<b>DOCKETED</b>	
<b>Docket Number:</b>	23-OPT-02
<b>Project Title:</b>	Darden Clean Energy Project
<b>TN #:</b>	258490
<b>Document Title:</b>	CEC Data Request Response Set 5
<b>Description:</b>	Provides the Applicant's fifth response set to data requests received from the CEC. Responses address data requests related to Biological Resources, Hazardous Materials Handling, Project Description, Water Resources, and Worker Safety. The document includes the following appendices to support responses: Appendix A REV 1 DR HAZ-1 Supplemental Soil and Water Sample Results, Appendix B REV 1 DR WS-1 Updated Fire Alarm Site Plan, Appendix C REV 1 DR WS-2 Fire Protection Engineering and UL 9540A Interpretation Report, Appendix D REV 1 DR WS-2 Tesla Megapack 2/XL Hazard Mitigation Analysis, and Appendix E REV 1 DR WS-3 Lithium-ion Battery Electrolyte Safety Data Sheets.
<b>Filer:</b>	Evelyn Langsdale
<b>Organization:</b>	Rincon Consultants

# Darden Clean Energy Project (23-OPT-02)

## CEC Data Request Response Set #5

Figure 1 Nitrogen Deposition ALL Project Options

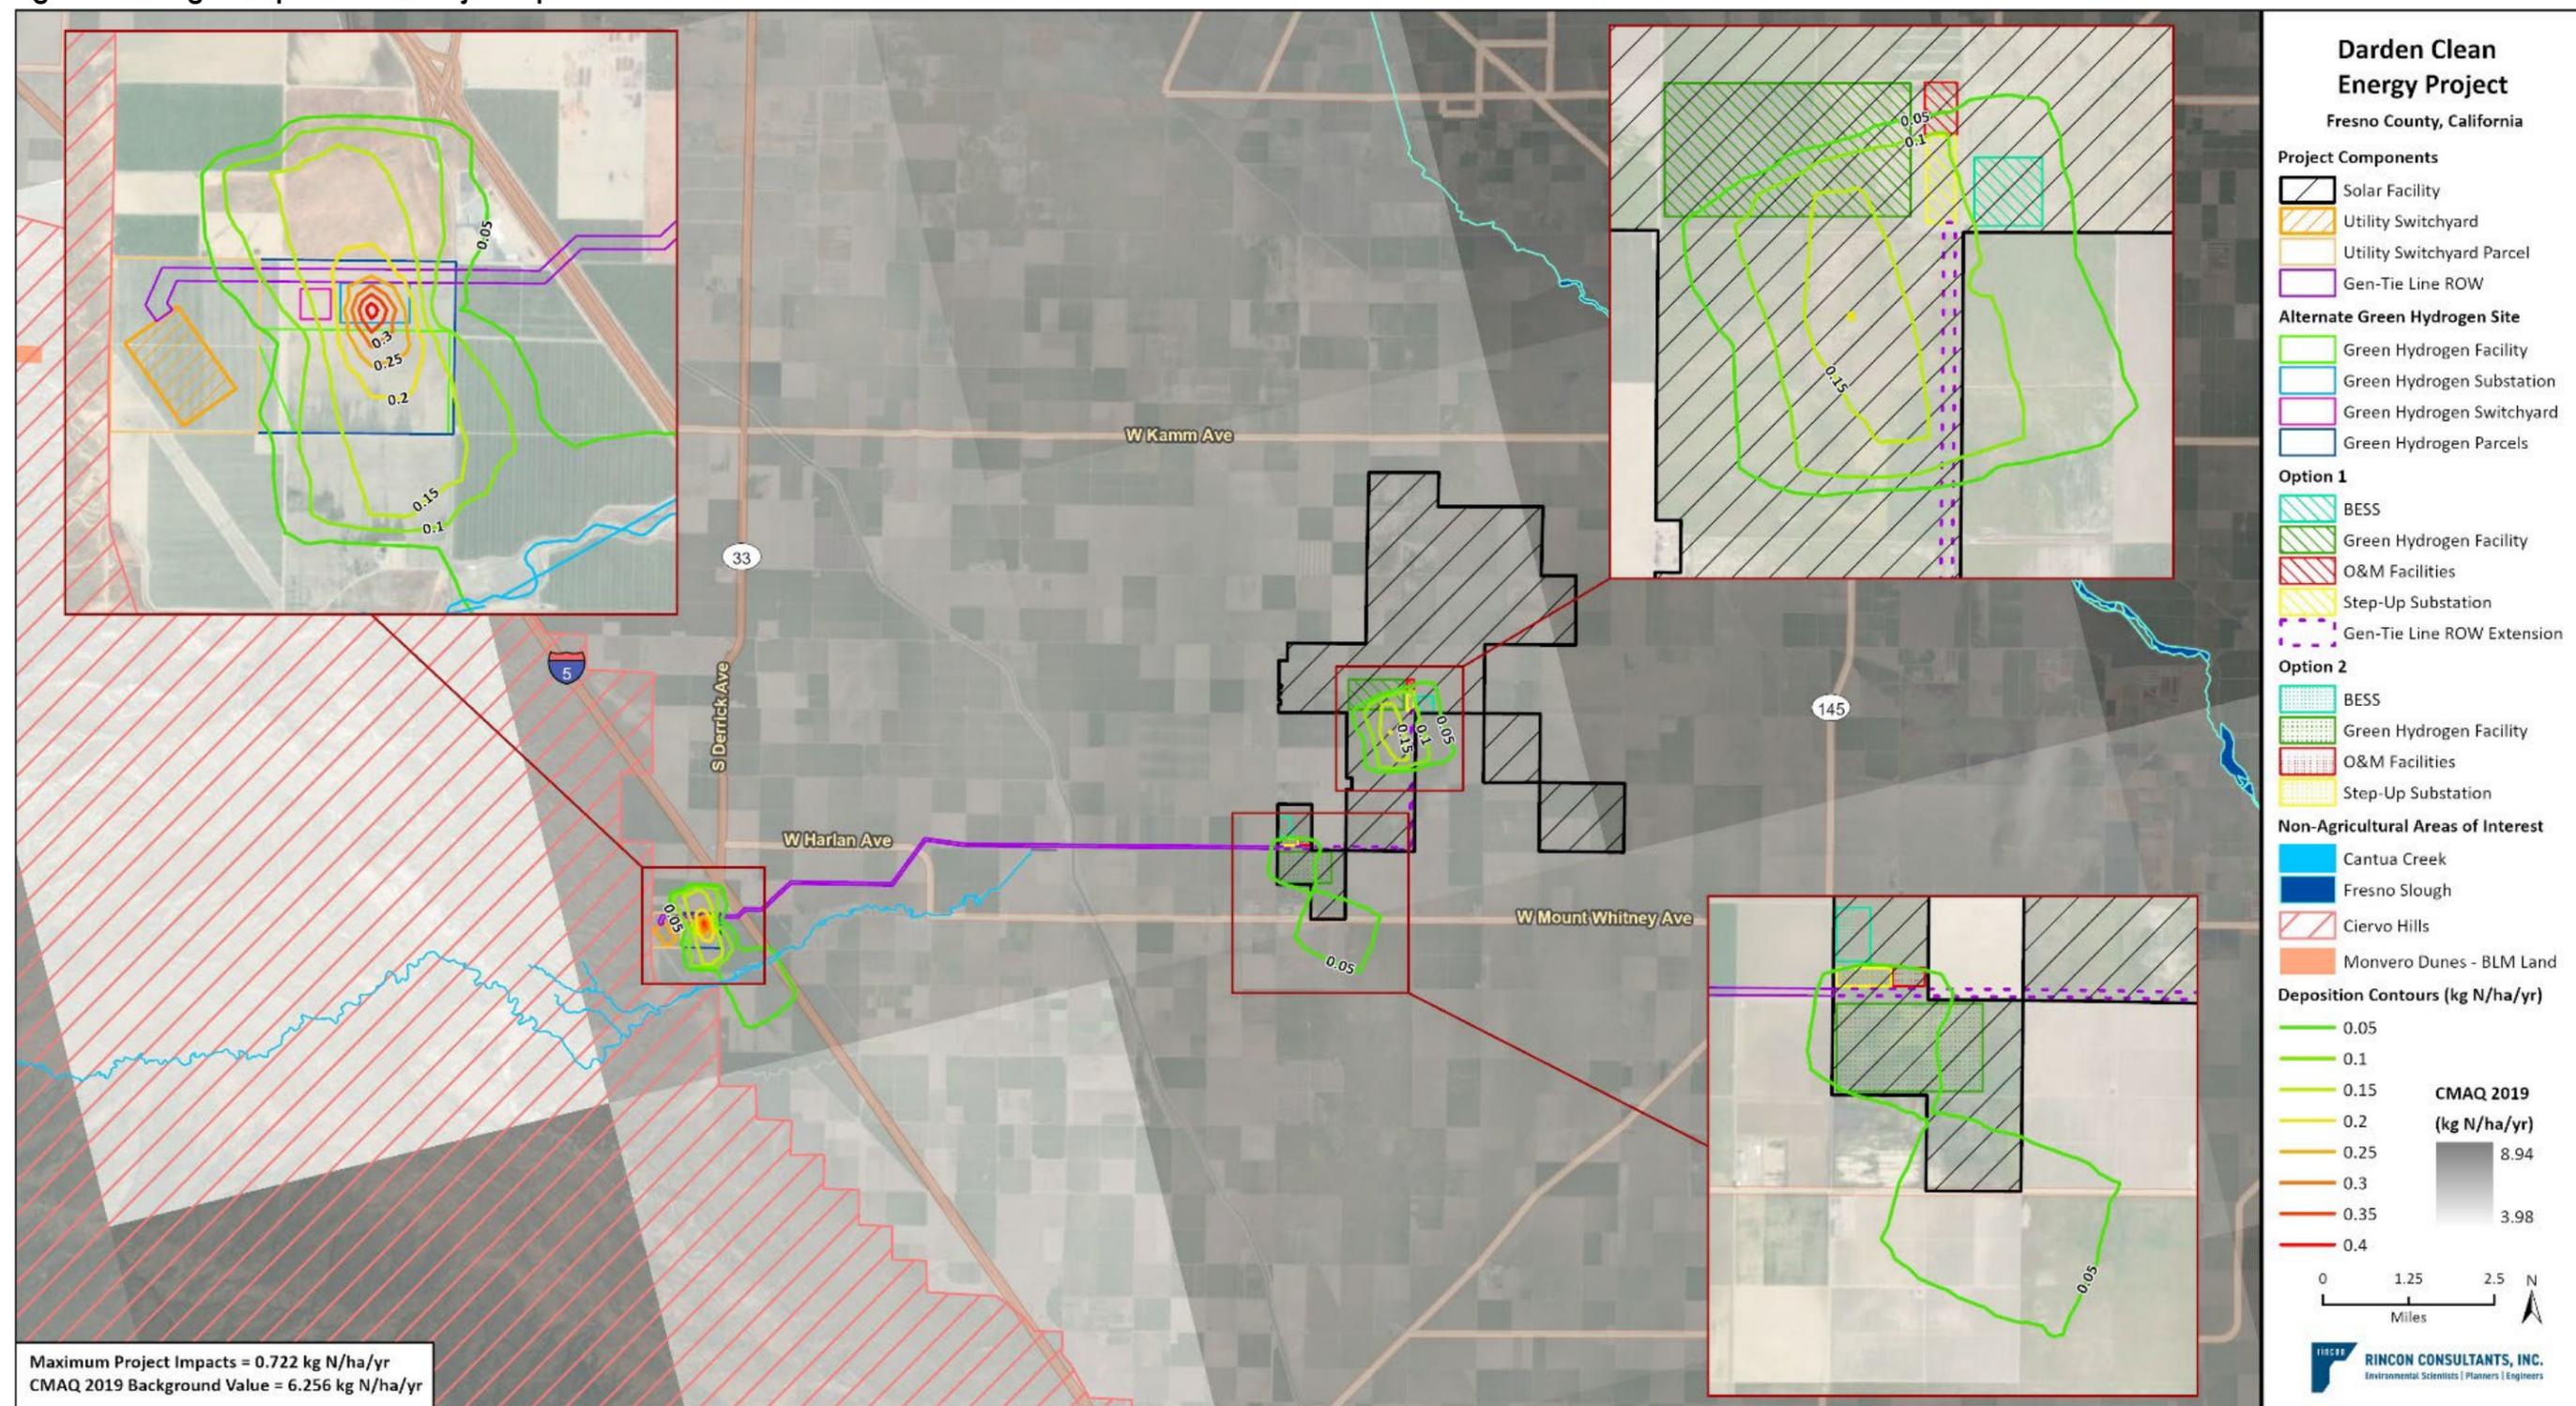
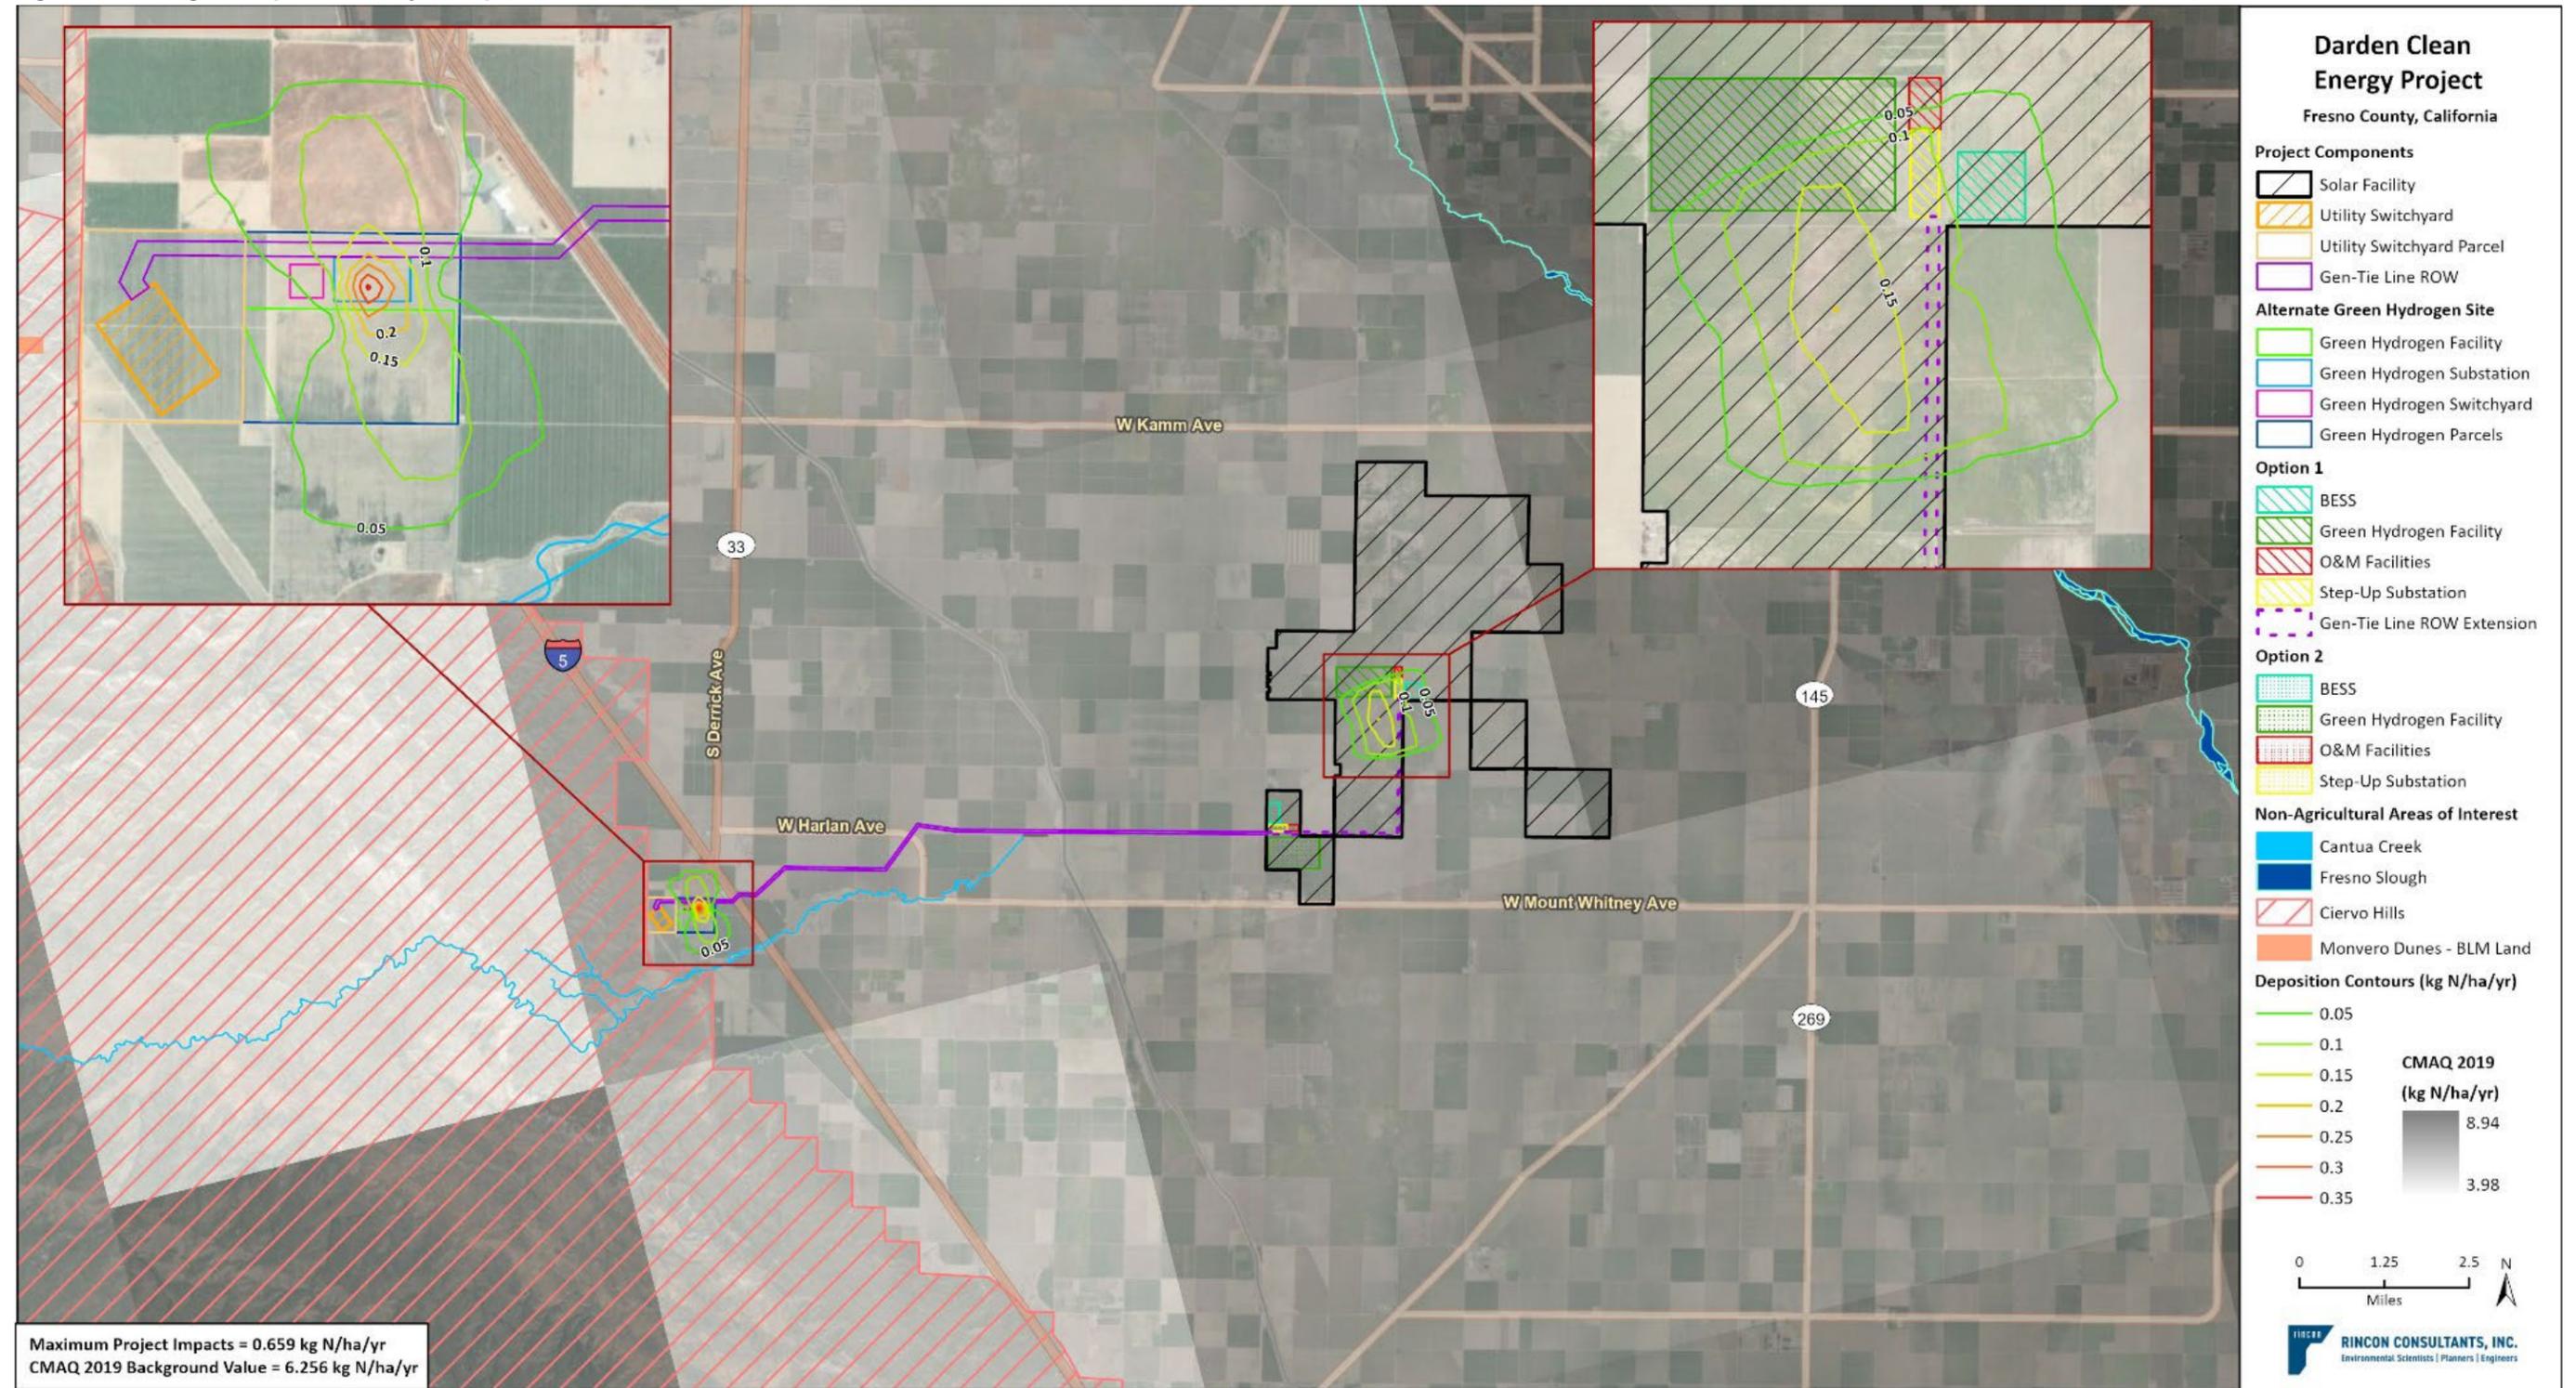
**REV 1 DR BIO-3:** In *CEC Data Request Response Set 4*, in response to staff's DR BIO-20, the applicant provided the maps in Appendix F. However, the maps are not in the correct units. Data was provided in g/m<sup>2</sup>, and the annual values were averaged across 5 years. Please provide revised map(s) for the total annual nitrogen deposition in kilograms of nitrogen per hectare per year (kg N/ha/yr). In adherence with Appendix B (g)(13)(B)(ii), Appendix B (g)(13)(C)(ii) and Appendix B (g)(15)(B)(ii), the maps should display the amount of total annual nitrogen deposition in kg N/ha/yr and should not be averaged across 5 years. Please refer to Great Oaks South Backup Generating Facility (20-SPPE-01) Draft Environmental Impact Report (TN 237875, pages 4.4-13 and 4.4-14), for an example of the expected mapped output, including mapped sensitive habitat, background values, and project features.

**Response:** Revised maps depicting the total annual nitrogen deposition in kilograms of nitrogen per hectare per year are provided in Figure 1 through Figure 4 below. The figures were revised to display the maximum annual nitrogen deposition values, rather than the 5-year average previously presented, which corresponded to a slight increase in annual nitrogen deposition values. The maps include project features, the non-agricultural areas of interest discussed in Appendix F of CEC Data Request Response Set 4, and background values.

The updated nitrogen deposition values presented in Figure 1 through Figure 4 show a maximum annual nitrogen deposition of 0.722 kg/ha/yr compared to the 5-year average of 0.684 kg/ha/yr previously discussed in Appendix F of CEC Data Request Response Set 4. The previous response also compared the modeled nitrogen deposition to average background nitrogen deposition values expected in this region of California (7-9 kg/ha/yr); however, the figures have since been updated with background 2019 CMAQ data (with a maximum of 6.256 kg/ha/yr). The results of the nitrogen deposition model also indicate the average nitrogen deposition rates using the source group "All" conservative approach would be on the order of  $1.0 \times 10^{-5}$  kg/ha/yr in the non-native grassland, dune and freshwater emergent wetland habitats and  $1.0 \times 10^{-4}$  kg/ha/yr along the Cantua Creek aquatic habitat and riparian corridor.

Therefore, the updated figures do not change the conclusions presented in the response to DR BIO-20 or Appendix F in CEC Data Request Response Set 4. The modeled annual nitrogen deposition remains well below the critical loads at sensitive habitats, as discussed in Appendix F of Data Request Response Set 4.
